ILL. C. C. DOCKET NO. 709-0018KCS Exhibit No. 1**From:** Srikanth Honnur [SHonnur@KCSouthern.com]**Sent:** Monday, December 29, 2008 4:20 PM**To:** kirk.brown@illinois.gov**Cc:** Glenn T. Hay; William J. Fleis; SJEFFERY@thompsoncoburn.com; David Reeves; Paul Fetterman**Subject:** FW: I-255 Overpass @ Godfrey, IL Meeting w/IDOT

Re: FAP 310 (IL 255) KCS M.P. 28.6

Section 60-15VB-1 & 2 Godfrey Subdivision

KCS Railroad Questions

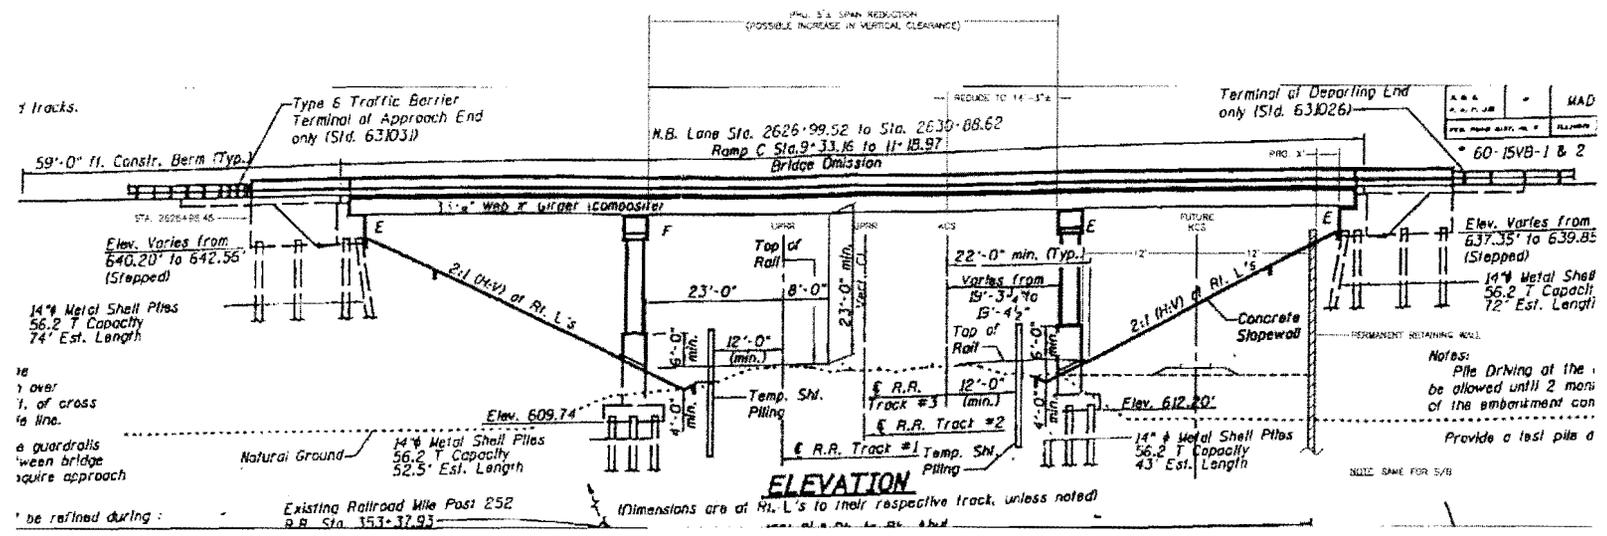
As discussed during the recent meeting between the Illinois Department of Transportation ("IDOT") and The Kansas City Southern Railway ("KCS"), the primary concern over the engineering design for the proposed Illinois Route 255 overpass is the lack of room for any future expansion that would allow for a second KCS track. While KCS certainly appreciates IDOT's willingness to accommodate most all the other KCS engineering concerns, this inability to add a second track creates a perpetual impediment to future operational growth and efficiency, and is contrary to standard KCS engineering policy in dealing with overpass projects.

In order to afford KCS the ability to add a second track at this location, the KCS engineering staff has prepared the enclosed engineering drawing.

Under this alternate proposal, the middle span length is reduced and the end span length is increased to give enough space for a retaining wall in front of the abutment. The current span configuration will not allow enough room at the end span for the second track. The battered piles supporting the abutment will intersect the retaining wall if the wall is built with the shorter end span. Another option could be to build a vertical abutment with pile cutoff points below the future track elevation. With the preferred option, no significant redesign will be required as the currently proposed abutment and pier details can still be used with a run of the mill standard concrete beam spans the designs of which already exist as state standards. The by product of using shorter spans is that a higher vertical clearance is achieved. The only re-design will be of the retaining wall which can be done with steel z-section sheeting.

N/B I-255 OVERPASS
GODFREY, IL

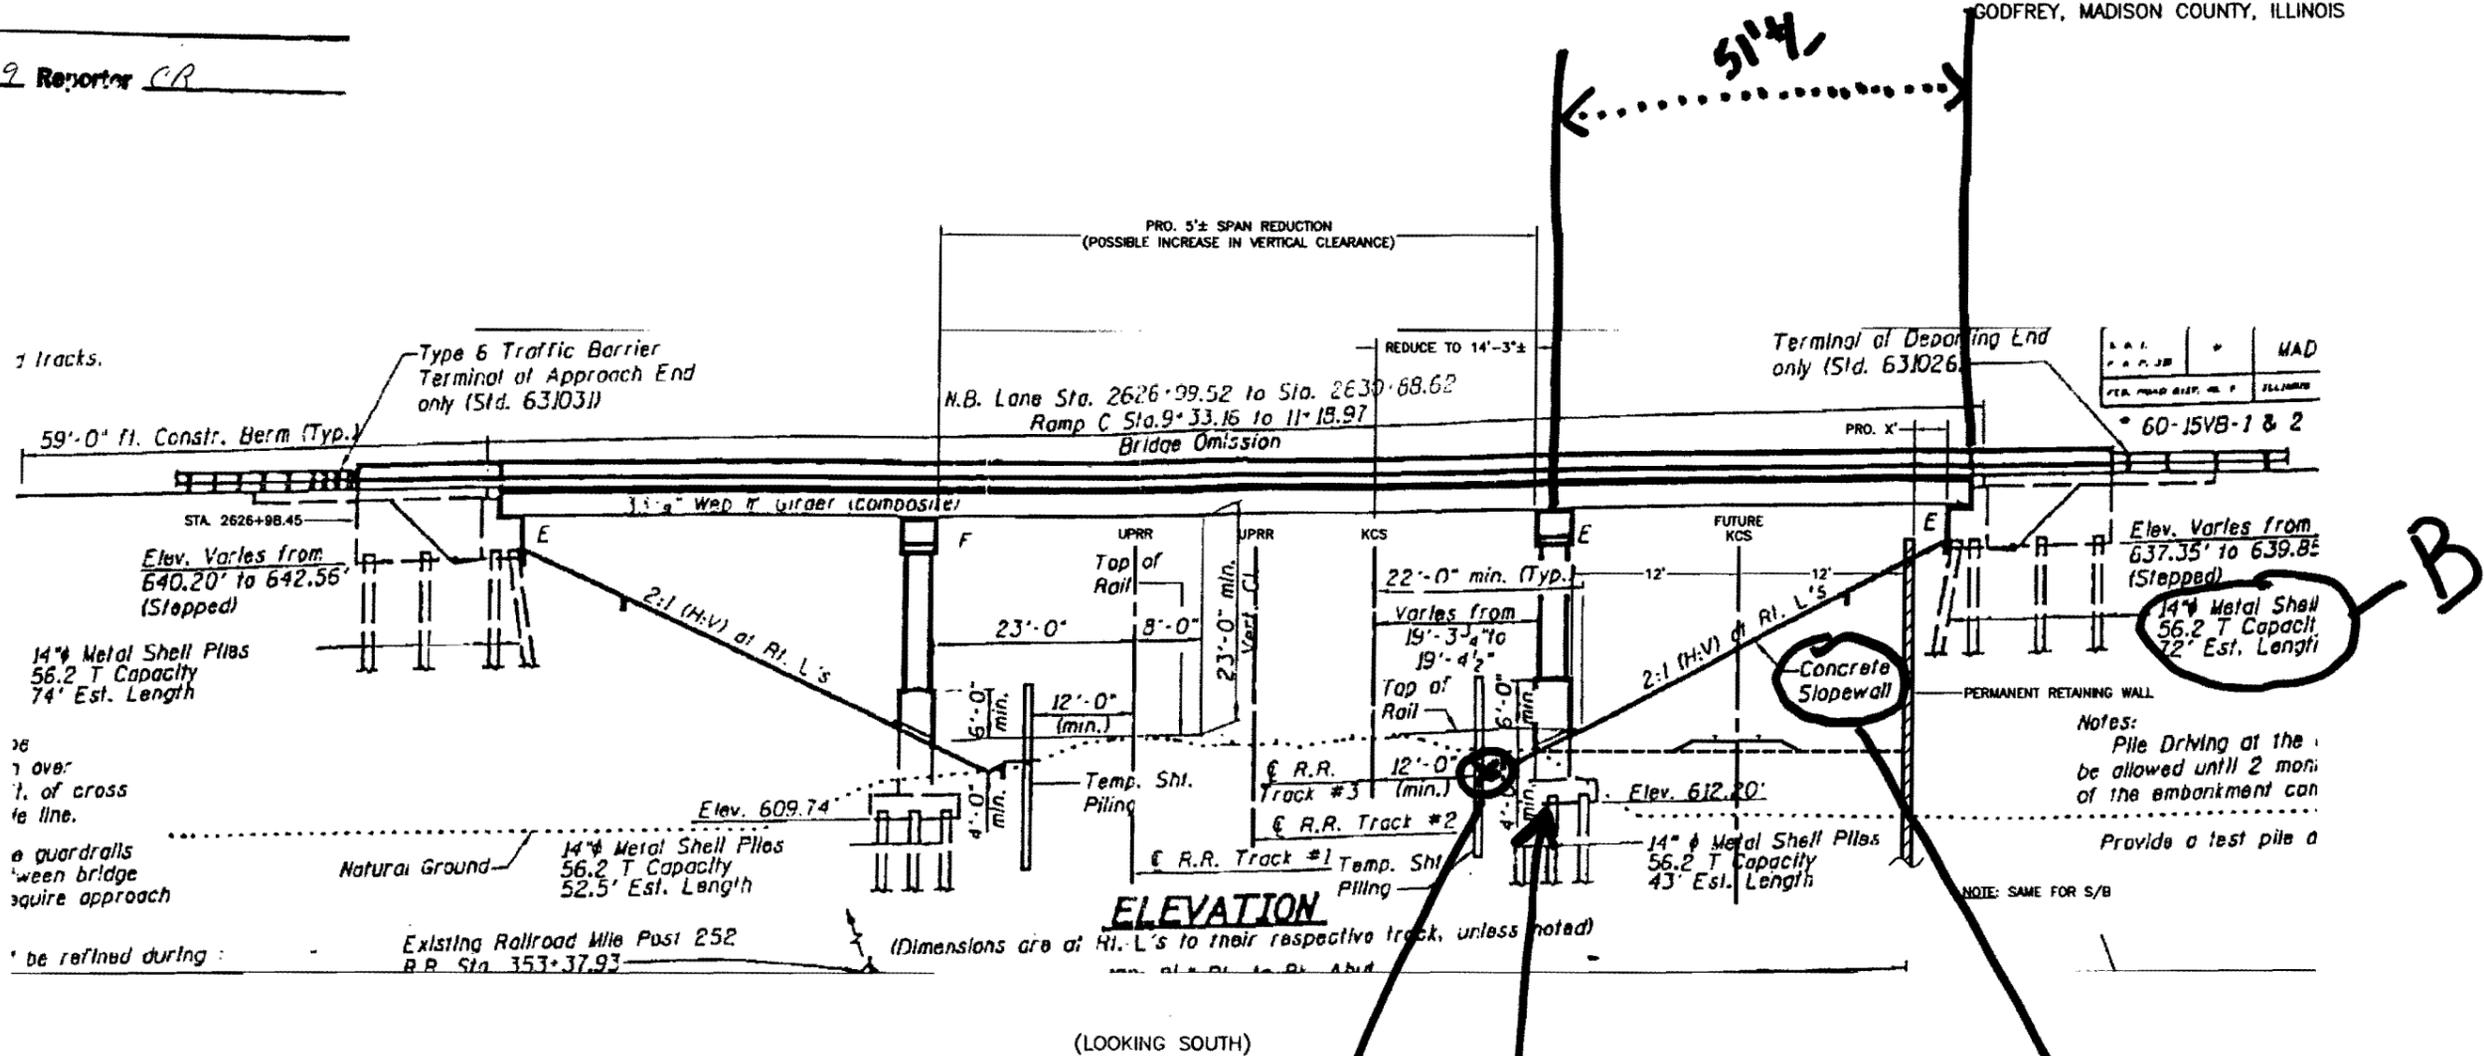
I wanted to follow-up to see if IDOT has had the chance to review the revised Ill-255 overpass drawing that would afford KCSR the capability to add an additional future track.
